official SCCA member notification
Fastrack news
EFFECTIVE FIRST DAY OF THE MONTH UNLESS OTHERWISE NOTED

CLUB RACING BOARD MINUTES

CLUB RACING BOARD MINUTES | December 1, 2020 **REVISED 5/21/2021**
The Club Racing Board met by teleconference on December 1, 2020. Participating were Peter Keane, Chairman; David Arken, David Daughtery, Jim Goughary, John LaRue, Paula Hawthorne, Sam Henry, and Shelly Pritchett, secretary. Also participating were: Bob Dowie and Marcus Meredith, BoD liaisons; Eric Prill, Chief Operations Officer, Deanna Flanagan, Director of Road Racing, Rick Harris, Club Racing Technical Manager and Scott Schmidt, Series Tech Chief. The following decisions were made:

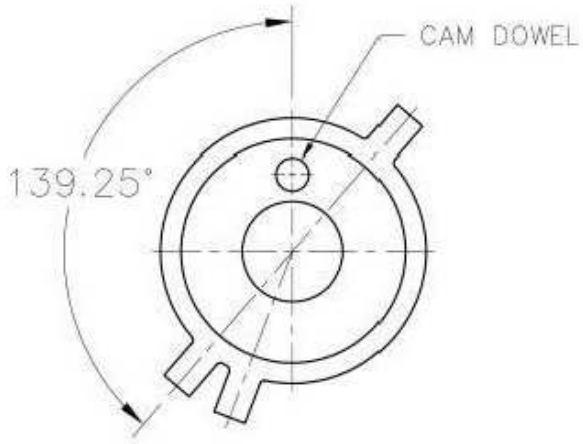
Lobe(s): Exhaust

LIFT	DUR.	OPEN	CLOSE	AREA
0.020	233.13	35.67 BBDC	17.46 ATDC	26.01
0.030	222.30	30.90 BBDC	11.40 ATDC	25.88
0.040	215.79	27.76 BBDC	8.04 ATDC	25.72
0.050	210.69	25.25 BBDC	5.43 ATDC	25.65
0.060	206.06	22.95 BBDC	3.11 ATDC	25.52
0.070	201.54	20.69 BBDC	0.85 ATDC	25.38
0.080	197.04	18.44 BBDC	1.40 BTDC	25.21
0.090	192.53	16.18 BBDC	3.65 BTDC	25.02
0.100	188.03	13.93 BBDC	5.90 BTDC	24.70
0.150	165.61	2.71 BBDC	17.10 BTDC	23.40
0.200	142.71	8.80 ABDC	28.49 BTDC	21.39
0.250	116.27	22.16 ABDC	41.56 BTDC	18.41
0.300	82.10	39.43 ABDC	58.47 BTDC	13.69
0.348	--- PEAK CAM LIFT ---

Figure 1"

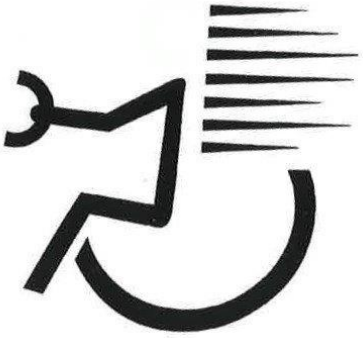
GCR
1. #30407 (Stephen Hyatt) Disability identification
In GCR, Section 9.3.29.E, change as follows:
"E. Disability Identification
~~To ensure course marshals, emergency services crew, and other officials are made aware that the driver may need to be dealt with differently in case of an emergency, non-ambulant drivers must display the disability identification symbol on both sides of the car near the driver's compartment.~~*If the driver will need assistance getting out of their car, the Mobility & Impairment decal (Figure 1), available in the online store or by calling Member Services, shall be displayed on the driver's door on closed wheel cars and adjacent to the master switch on formula and sports racer type cars.*

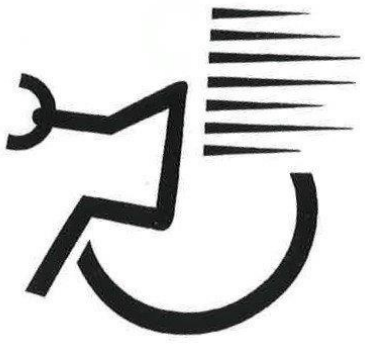
1. #30407 (Stephen Hyatt) Disability identification
In GCR, Section 9.3.29.E, change as follows:
"E. Disability Identification
~~To ensure course marshals, emergency services crew, and other officials are made aware that the driver may need to be dealt with differently in case of an emergency, non-ambulant drivers must display the disability identification symbol on both sides of the car near the driver's compartment.~~*If the driver will need assistance getting out of their car, the Mobility & Impairment decal (Figure 1), available in the online store or by calling Member Services, shall be displayed on the driver's door on closed wheel cars and adjacent to the master switch on formula and sports racer type cars.*
Figure 1"
